PROJECT:
SINGLE-FAMILY RESIDENCE (FIRE REBUILD)
DETACHED GARAGE
ADDRESS:
15303 EARLHAM ST, PACIFIC PALISADES, CA 90272

**STAMPER
RESIDENCE
FIRE REBUILD**

**Cover Sheet /
Project Info /
Sheet Index**

Pre-Fire-Event Site Plan vs New Site Plan Comparison

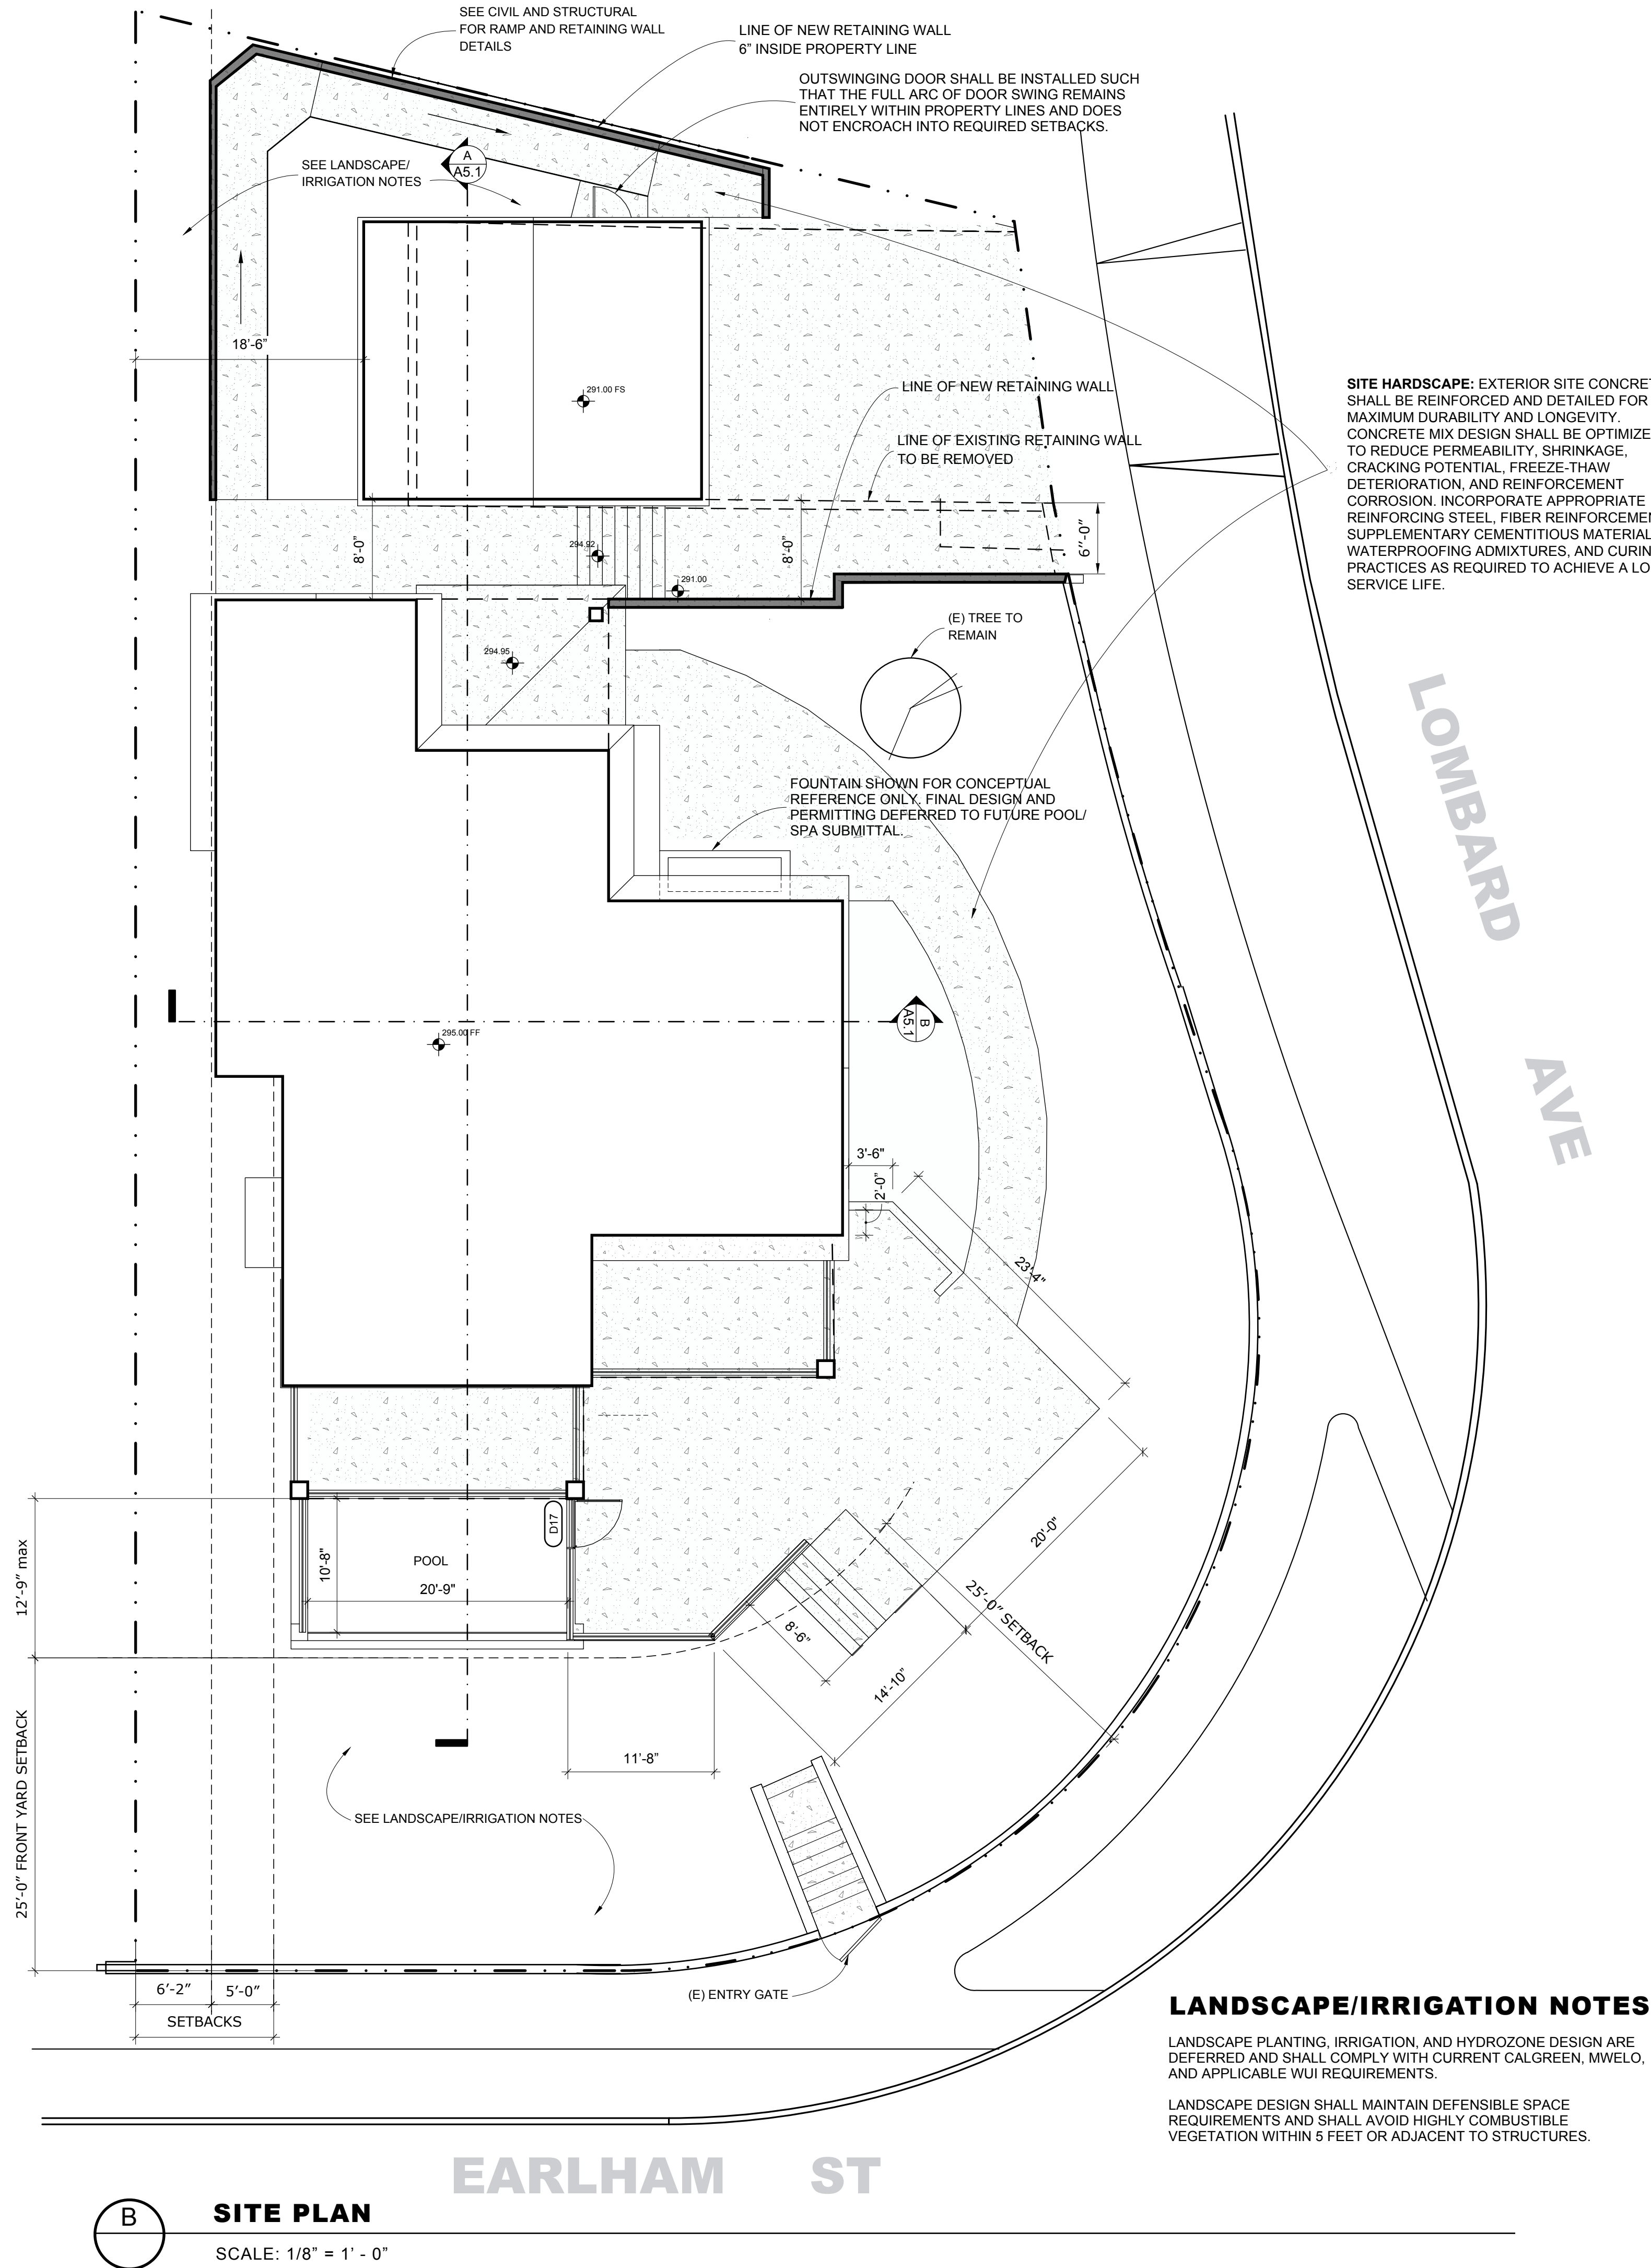
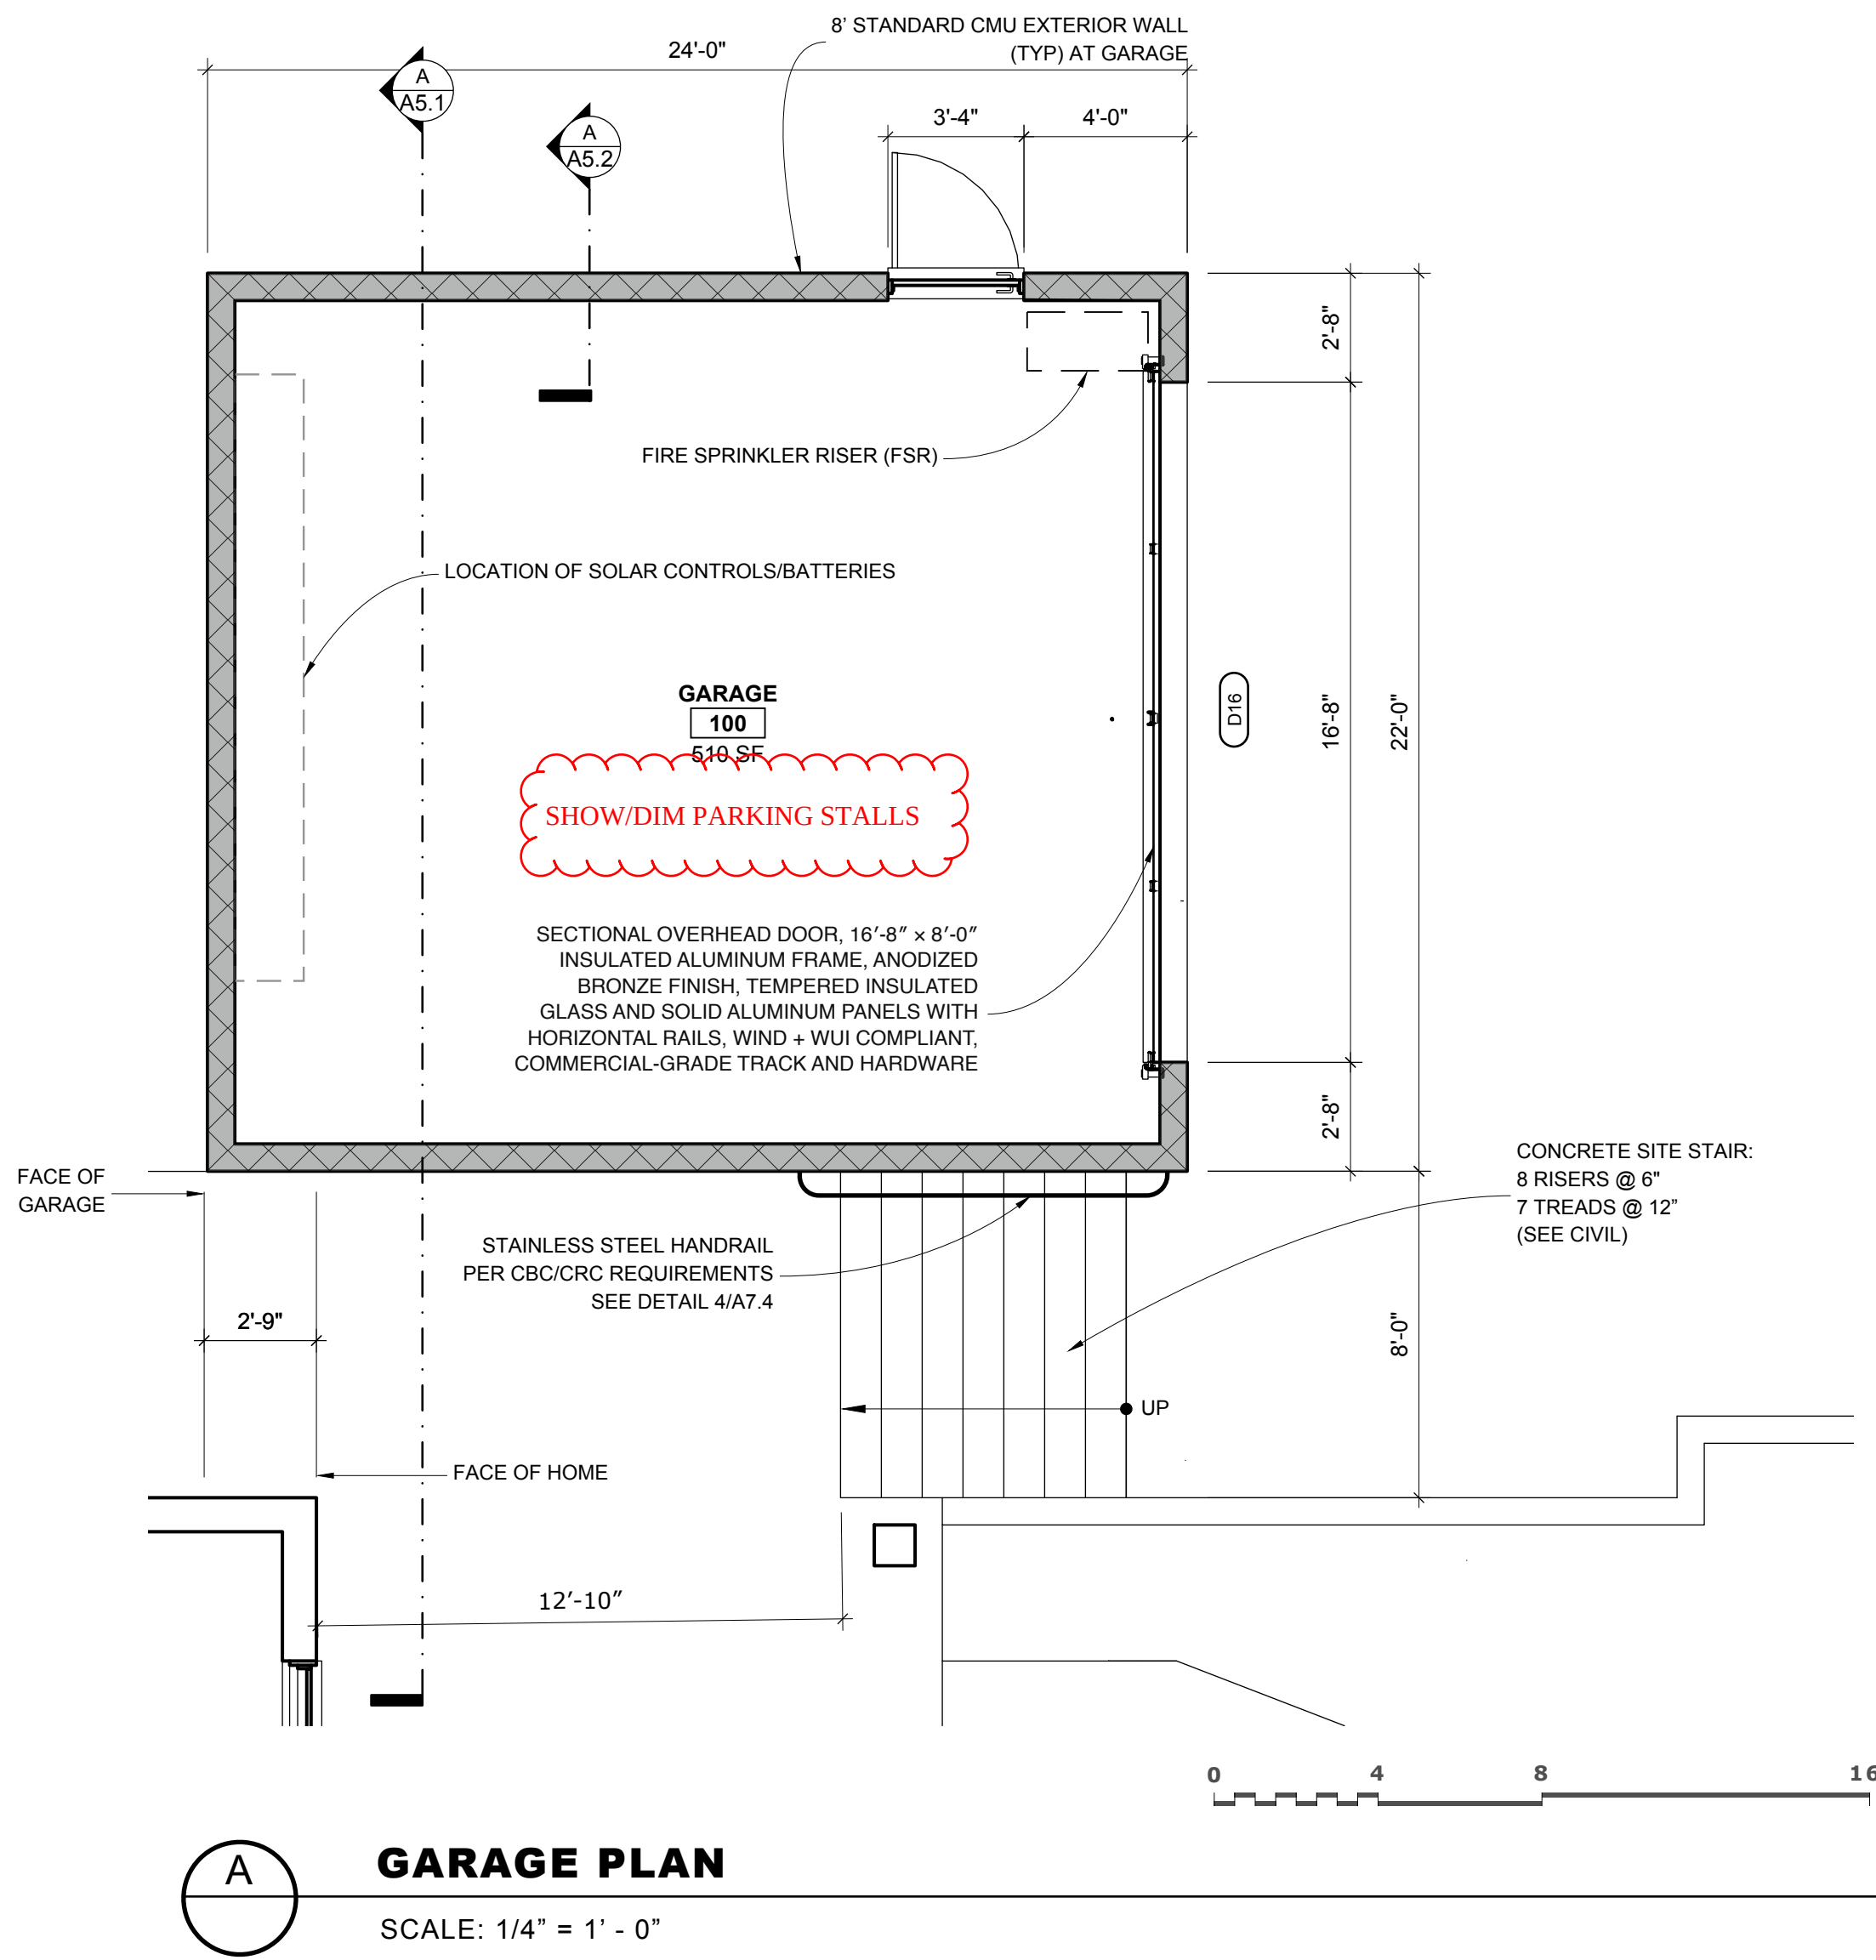
PROVIDE PROPERTY LINE DIMENSIONS

REVISE TO 20' THROUGHOUT

PROVIDE RETAINING WALL AND CIVIL PLANS FOR PROPOSED WALLS
ADDITIONAL SUBMITTAL AND PLAN CHECK WILL BE REQUIRED

First Floor Plan

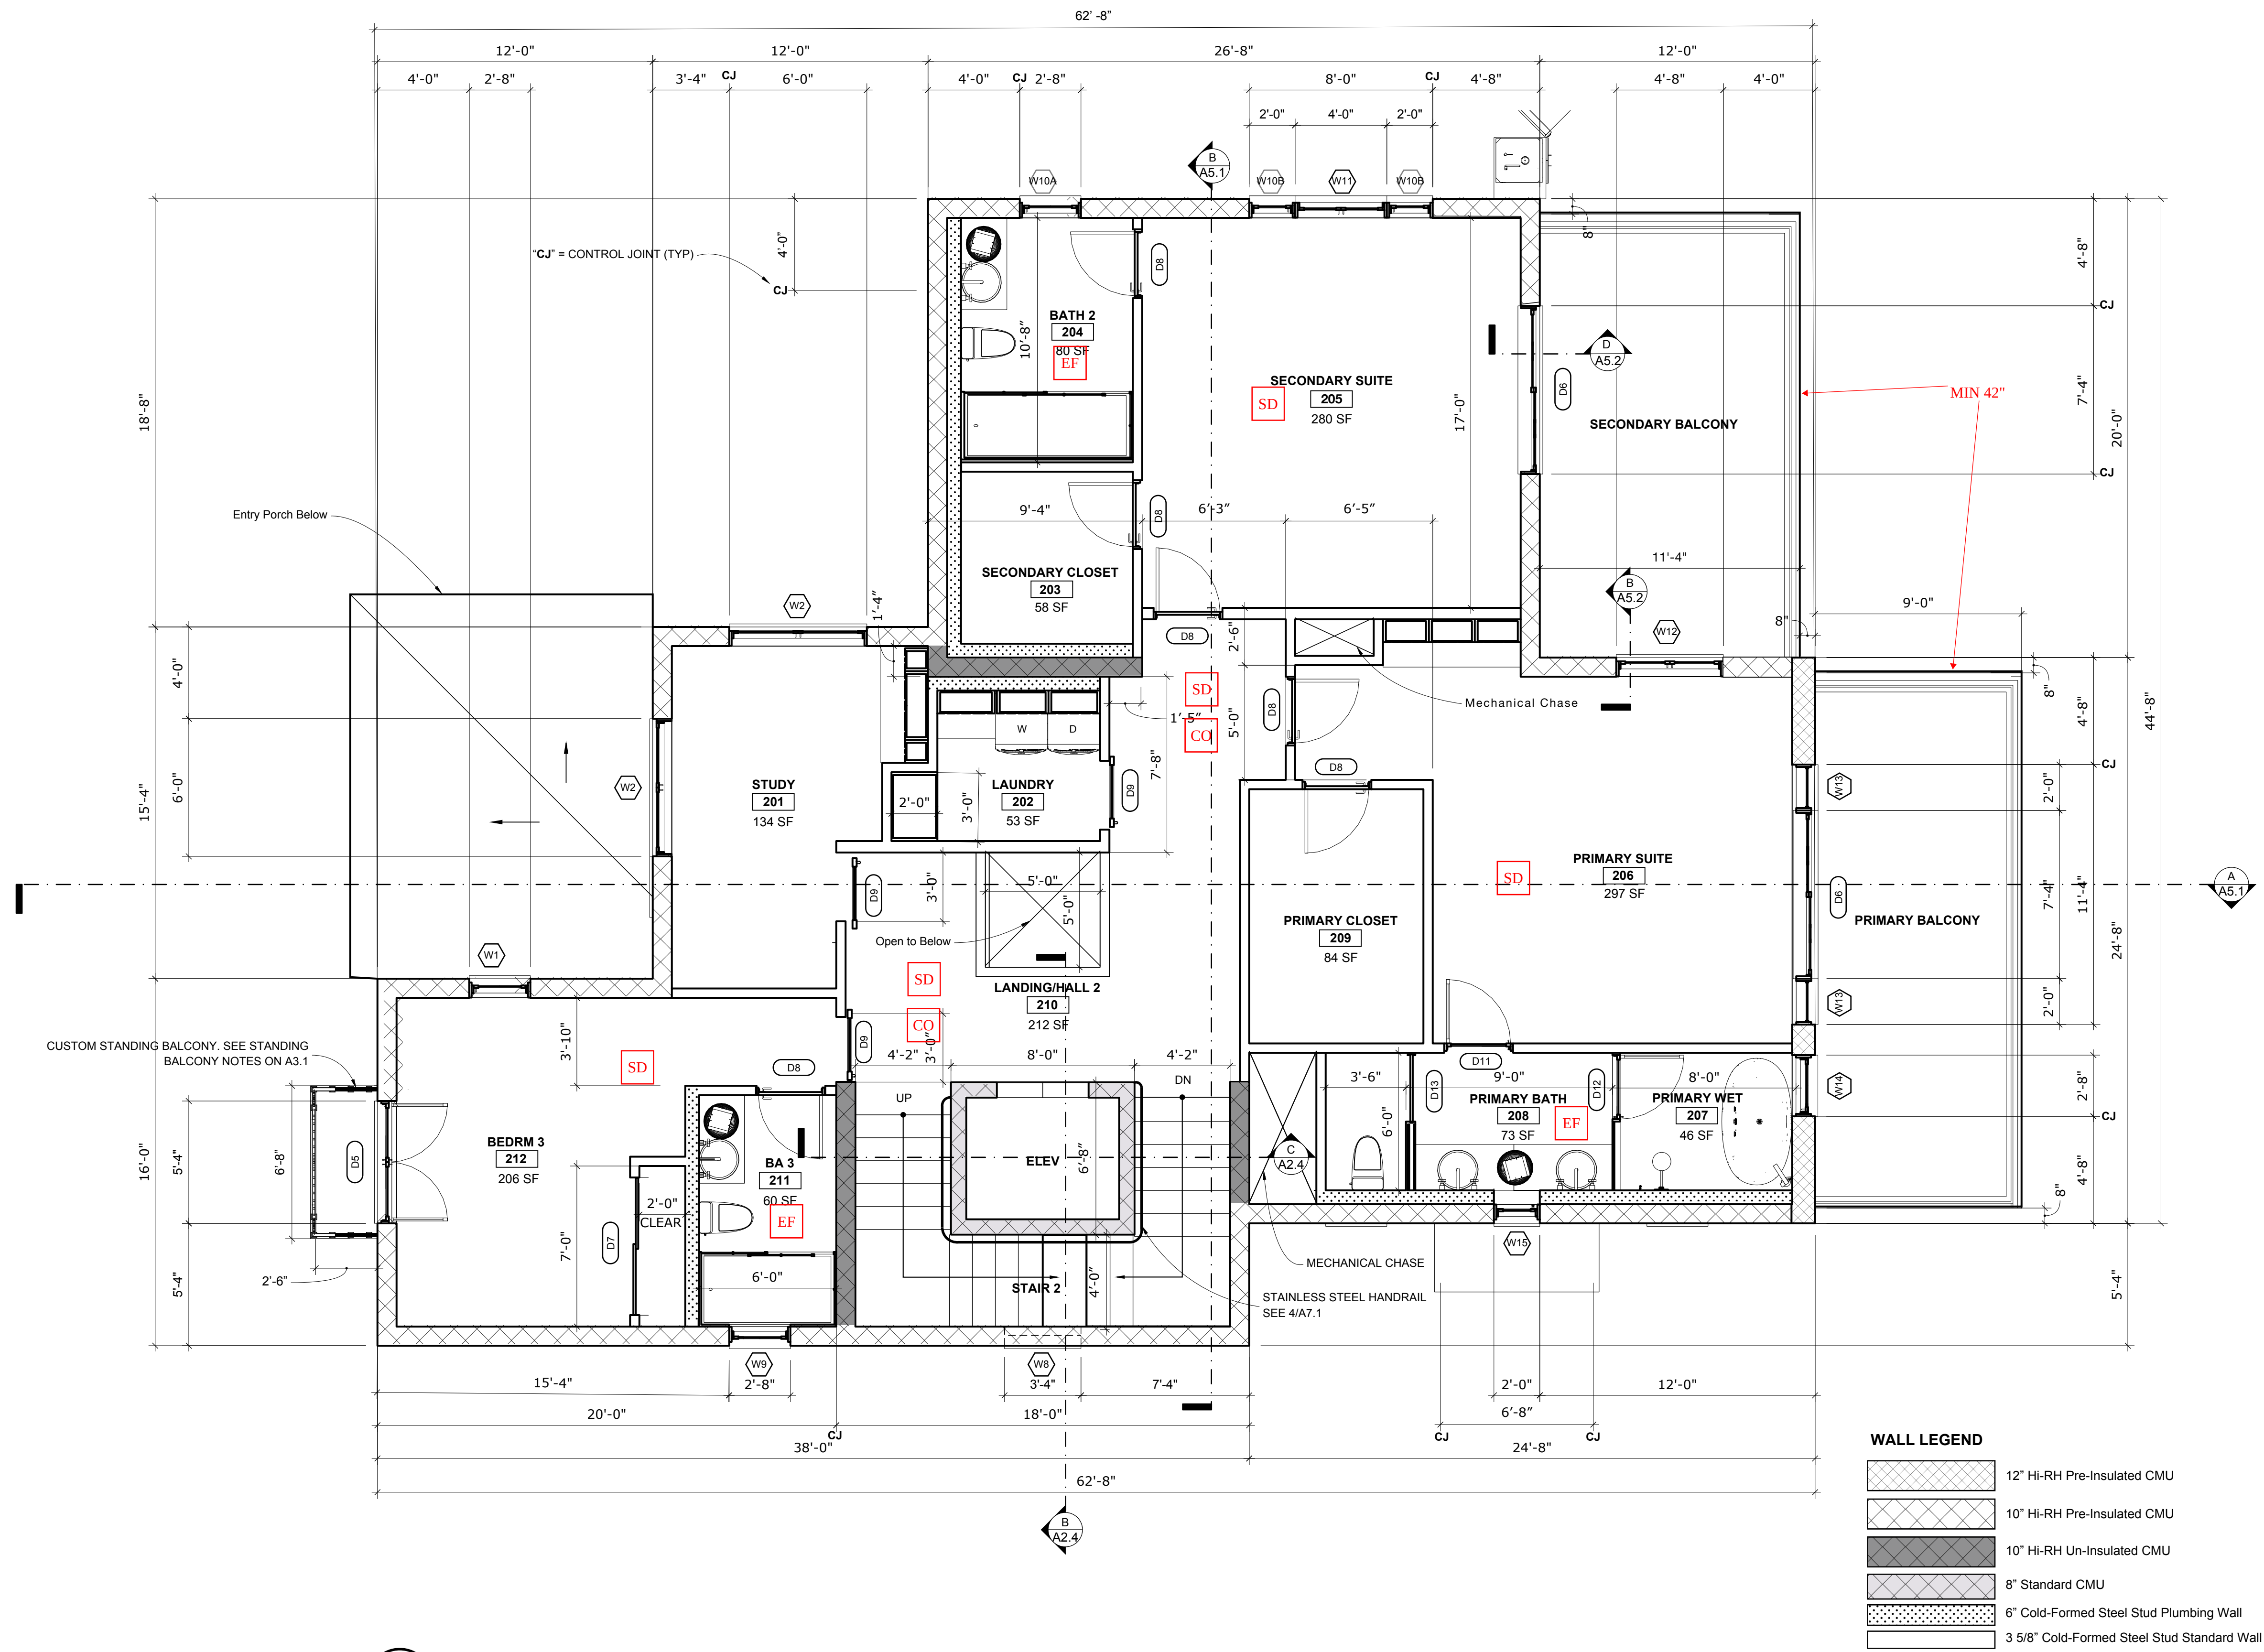
PROVIDE GRIDLINES ON FLOOR/ROOF PLANS
